Access Compliance Report

Public Rights-of-Way

Intersection ID: 22621	Main Street: SHARON_RD	Cross Street: GREENCASTLE_DR	Location: S
ADA ID: EF2D1F512AD3	Ramp Type: PerpDiag	Initial Pass/Fail: Fail	Overall Compliance: No
		Severity Score: 37.5

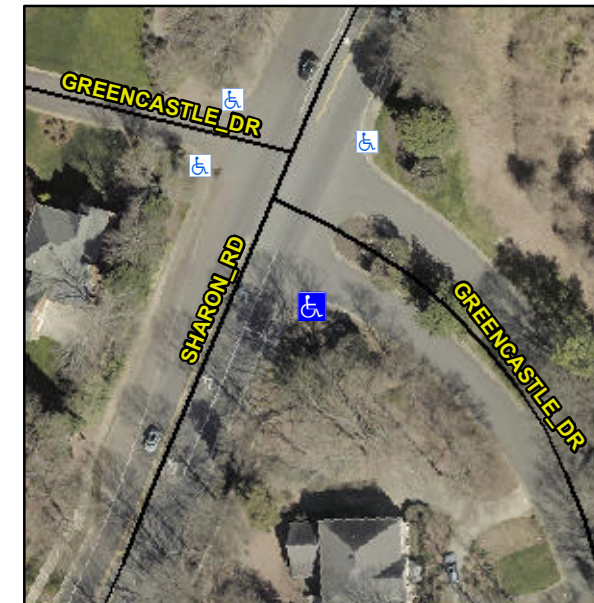
Not Found, R304.2.2, R304.5.3

Compliance	Description	Data	Compliance	Description	Data
N/A	Ramp Length (in)	60.0	No	Ramp Slope (%)	10.2
Yes	Ramp Width (in)	48.0	No	Ramp XSlope (%)	7.7
N/A	Flare Type LT	N/A	N/A	Flare Type RT	N/A
N/A	Flare Slope LT (%)	N/A	N/A	Flare Slope RT (%)	N/A
N/A	Flare Traversable LT?	N/A	N/A	Flare Traversable RT?	N/A
N/A	Landing Length (in)	N/A	N/A	DWS Provided?	N/A
N/A	Landing Width (in)	N/A	N/A	DWS Contrast?	N/A
N/A	Landing Slope (%)	N/A	N/A	DWS Length (in)	N/A
N/A	Landing X Slope (%)	N/A	N/A	DWS Full Width?	N/A
N/A	Landing Curb? (Y/N)	N/A	N/A	DWS Offset (in)	N/A
N/A	Shared Landing?	N/A			
N/A	Gutter Ponding?	N/A	N/A	Gutter Slope (%)	N/A
N/A	Gutter Lip Ht (in)	N/A	N/A	Gutter X Slope (%)	N/A
N/A	Painted X Walk1?	No	N/A	Painted X Walk2?	No
	X Walk 1 Direction	To NE		X Walk 2 Direction	To NW
N/A	X Walk 1 Width (in)	N/A	N/A	X Walk 2 Width (in)	N/A
	X Walk 1 Slope (%)	0.7		X Walk 2 Slope (%)	5.8
	X Walk 1 X Slope (%)	5.6		X Walk 2 X Slope (%)	0.6

Remove & Replace Curb Ramp With Two New Directional Ramps or Equivalent.
